Re: Supporting information for the PER and IESC responses for the Vulcan South Project

Date	16 August 2024
Attention	Damien Plucknett
Company	METServe
WRM ref.	1571-34-B2
Subject	Vulcan South – Supporting information for the PER responses

Supporting information and responses to the Independent Expert Scientific Committee Information Request relating to surface water

Figure 3.4 Existing Drainage line 6 features

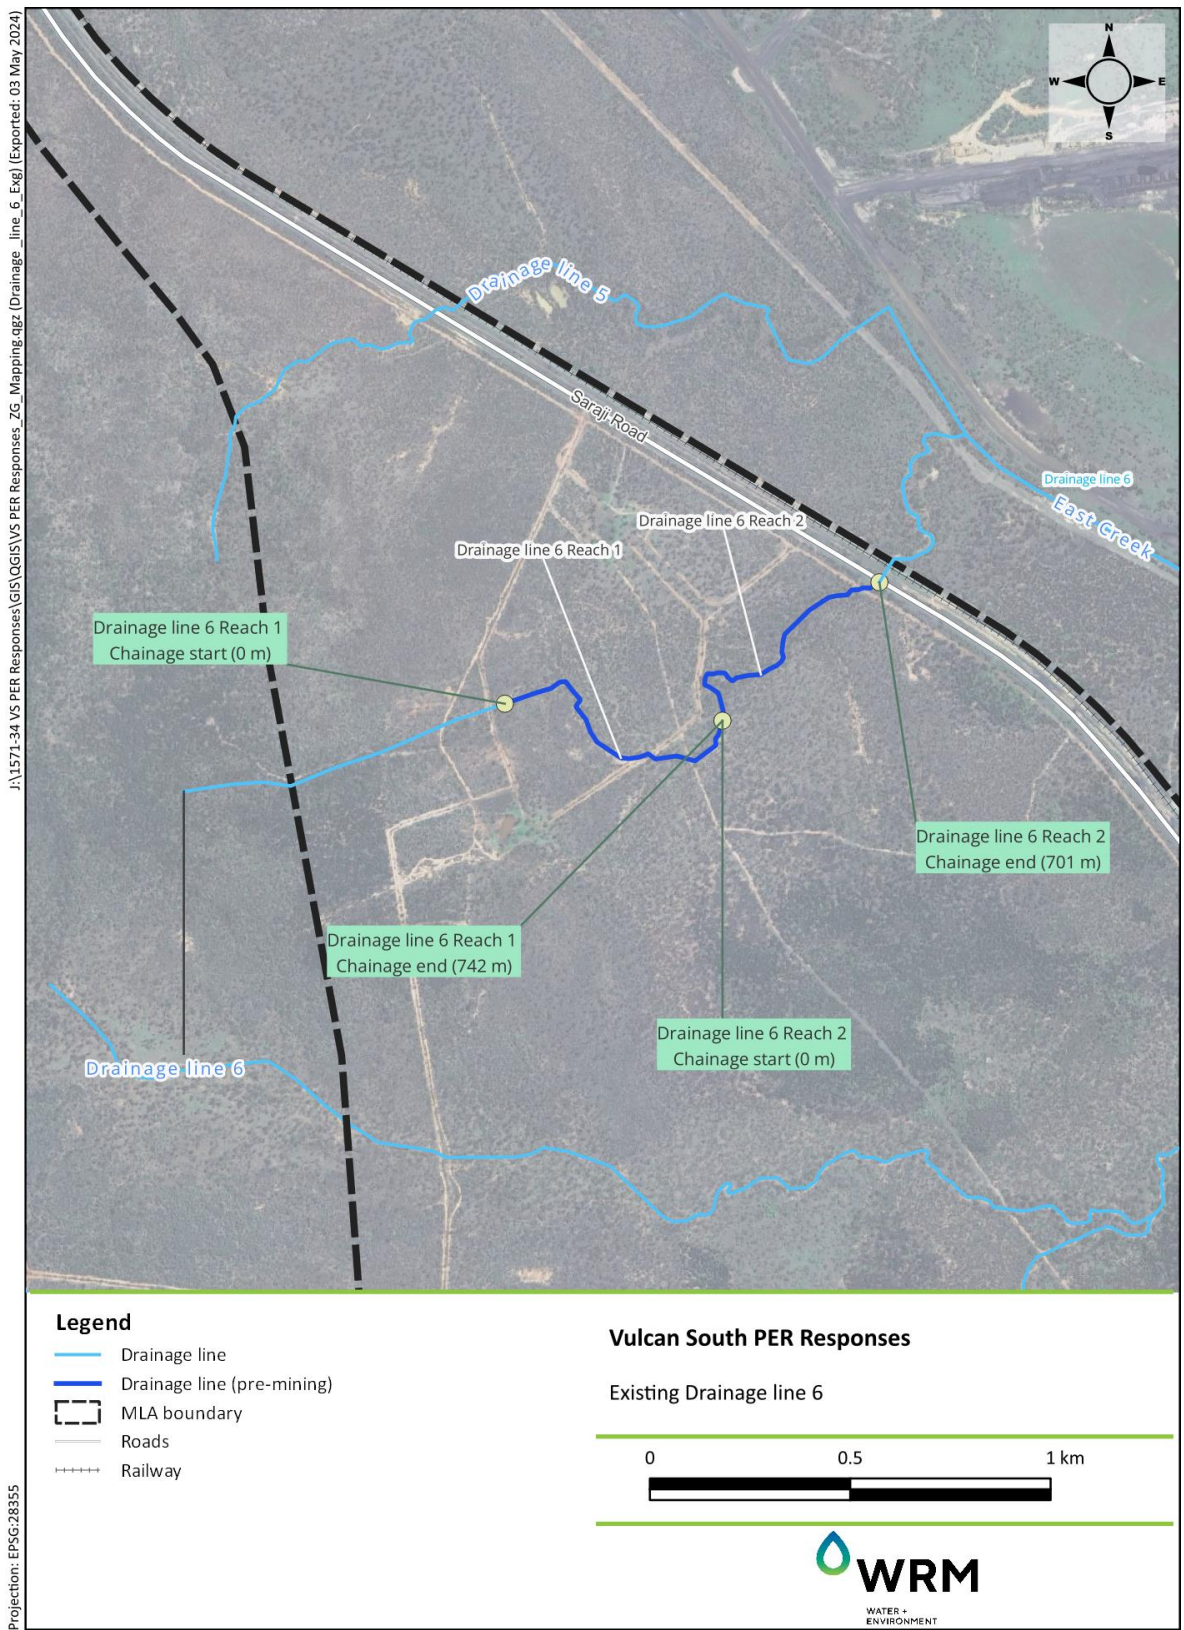
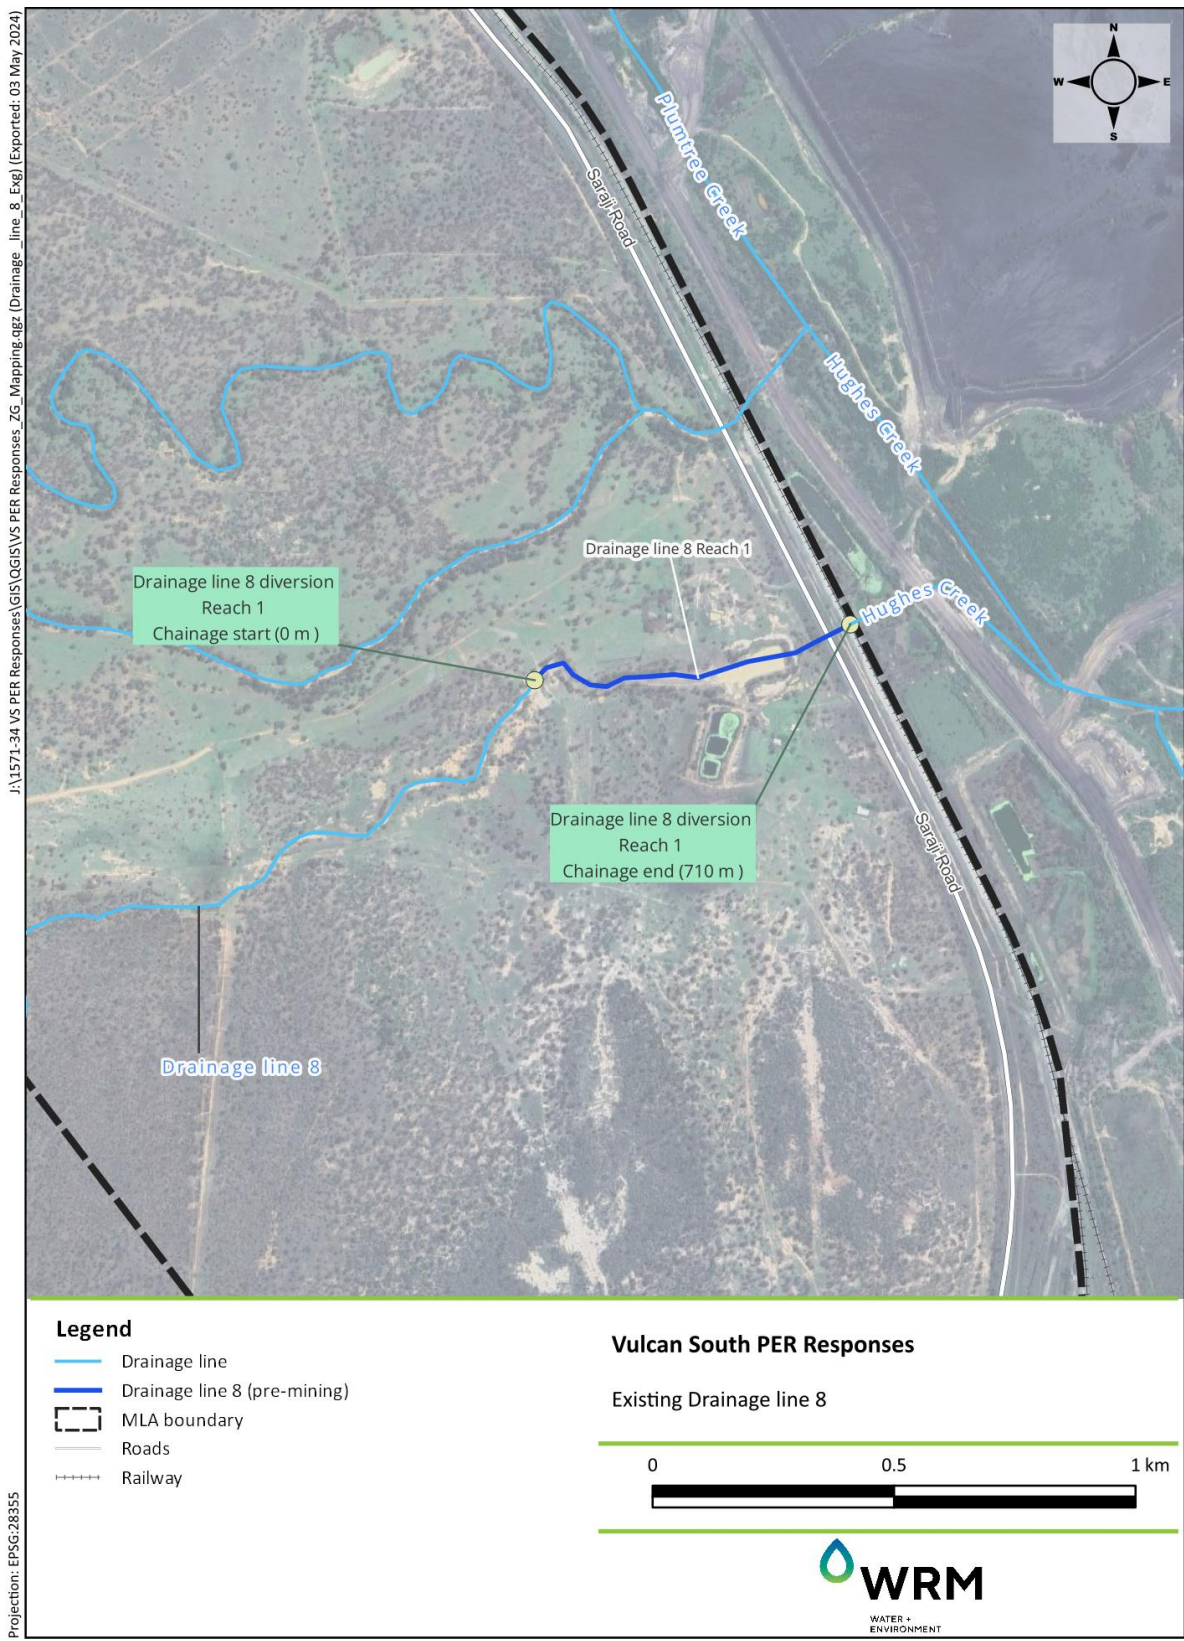
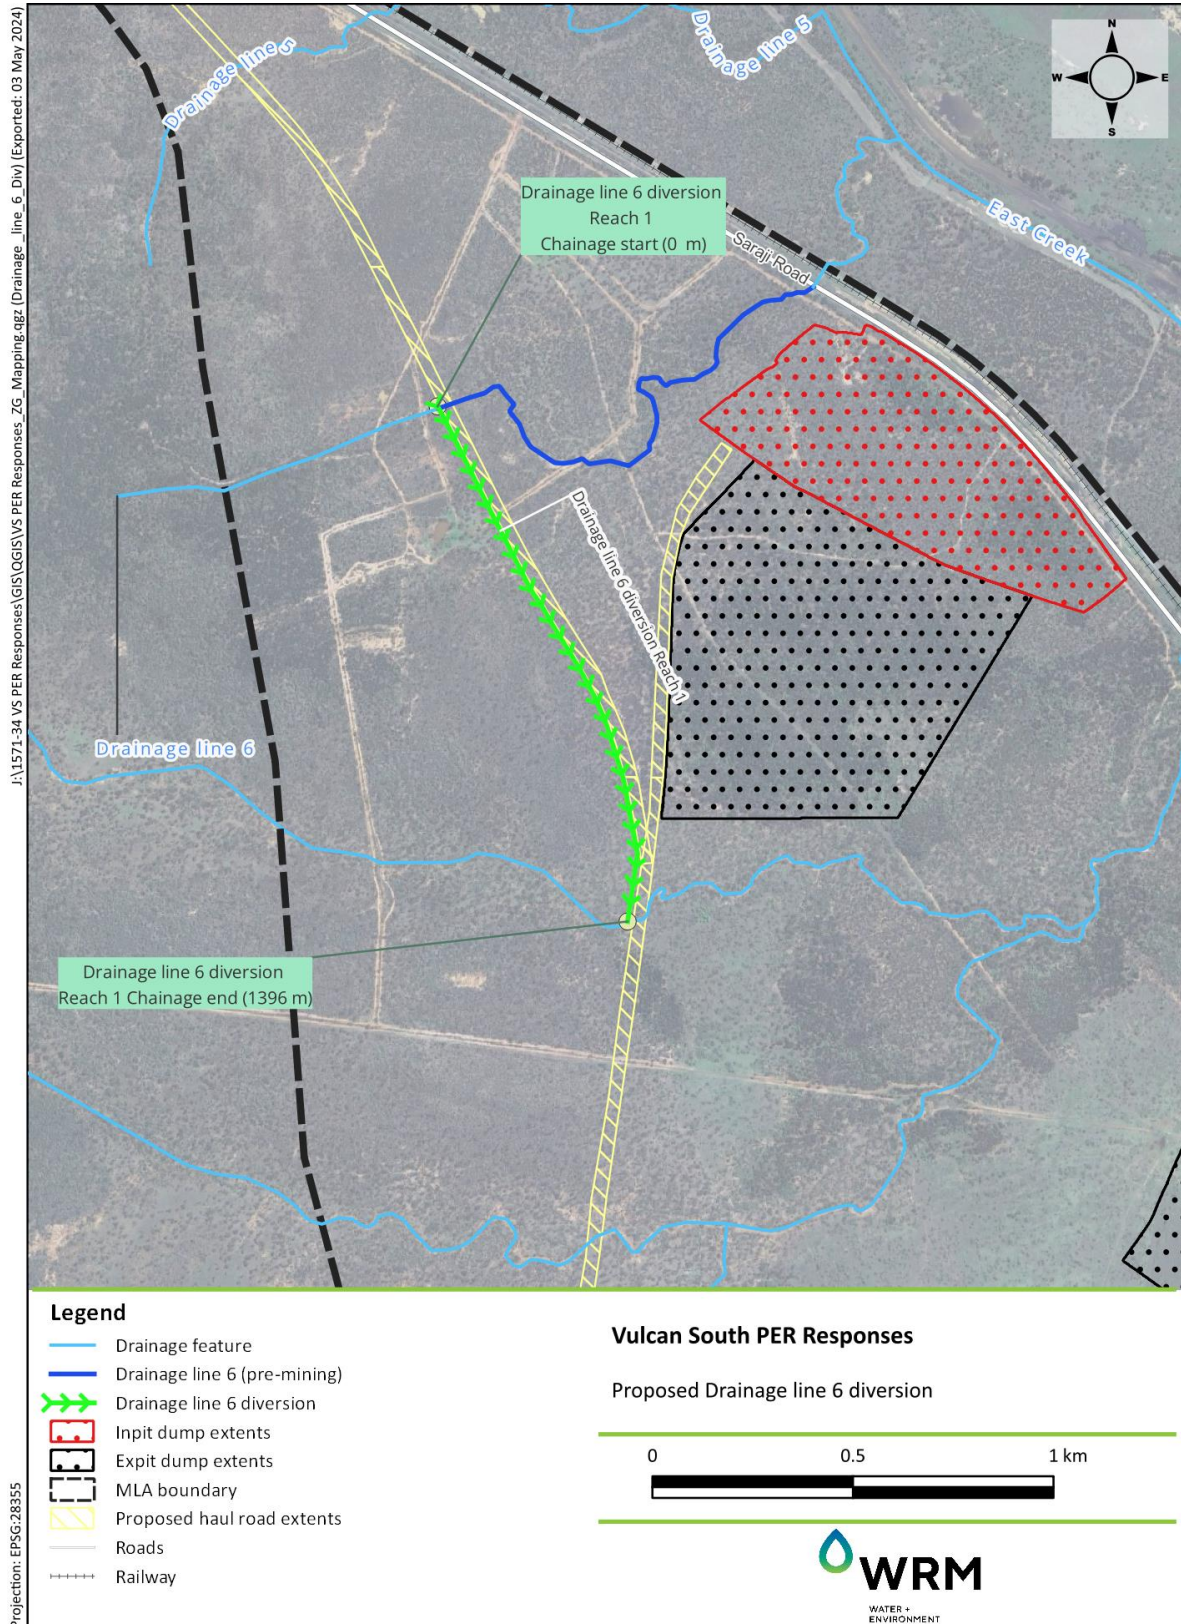
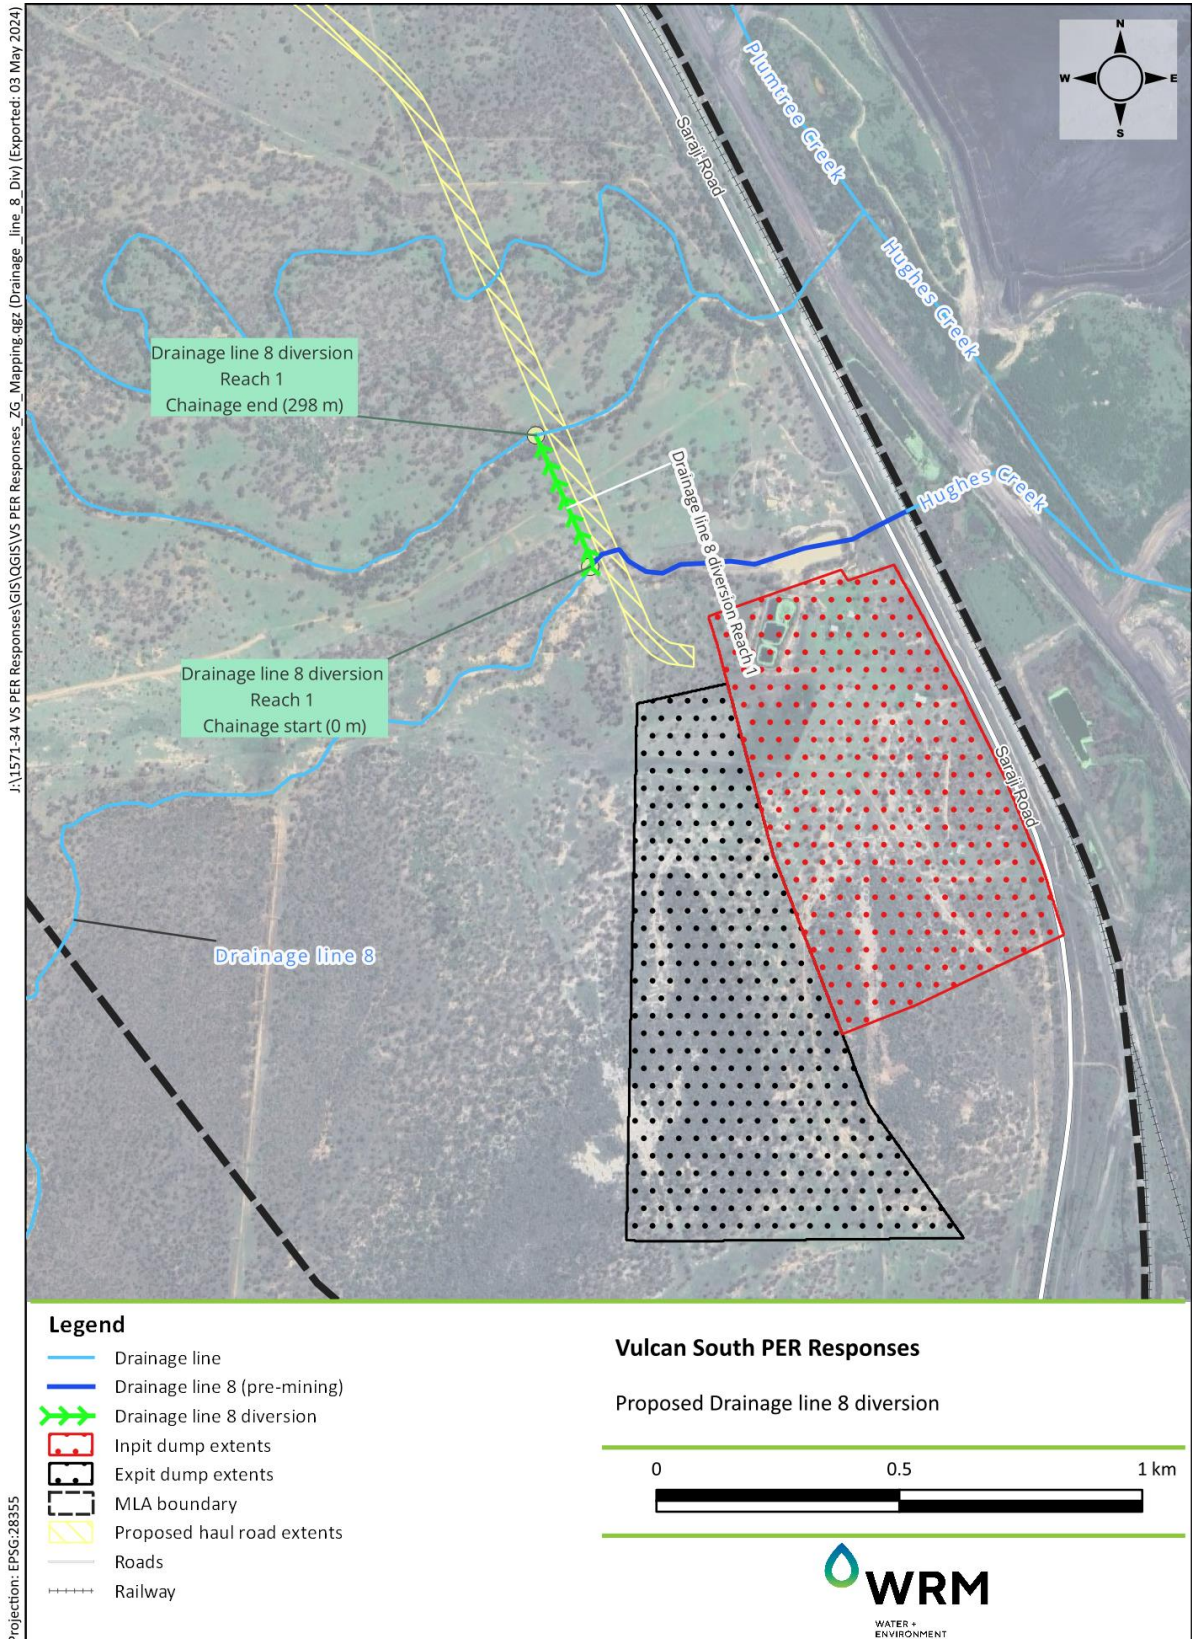
Provide additional information about the design of the proposed diversions for the three headwater streams around the pits.

Figure 3.4 to Figure 3.7 show the existing and diverted drainage lines reaches that have been assessed respectively. Table 3.3 and Table 3.4 presents the channel velocity (V), bed shear stress (BSS) and stream power (SP) along the existing and diverted drainage reaches for the 10% AEP and 1% AEP events. In summary, the proposed diversions should meet the DNRME (2019) hydraulic design objectives and key design outcomes for the diversions and receiving waters. The following is of note:

- Drainage line 6 diversion:
 - There are generally reductions in average and maximum V, BSS and SP values for both the reaches when compared with pre-mining conditions except for a small increase in average and maximum V when comparing Drainage line 6 diversion Reach 1 to the pre-mining Drainage line 6 Reach 2.

- The average channel V, BSS and SPs and maximum channel V are below the DNRME (2019) guideline values for all reaches with vegetation. The maximum values are greatly reduced along the diversion length compared to pre-mining conditions, however at point locations along the reach, the maximum values exceed the guideline values similar to pre-mining conditions, which highlights the need to revegetate or rock line the channel to limit erosion risk. It is recommended that this reach is monitored and remediation works implemented where required. Where significant erosion is expected, reprofiling and rock lining may be required to stabilise the reach.

- Drainage line 8 diversion:
 - There is an increase in average and maximum channel V, BSS and SP, however, the average values are below the DNRME (2019) guideline values for all reaches with vegetation.

- The maximum values exceed guideline values at point locations similar to pre-mining conditions, which highlights the need to revegetate or rock line the channel to limit erosion risk. It is recommended that this reach is monitored and remediation works implemented where required. Where significant erosion is expected, reprofiling and rock lining may be required to stabilise the reach.
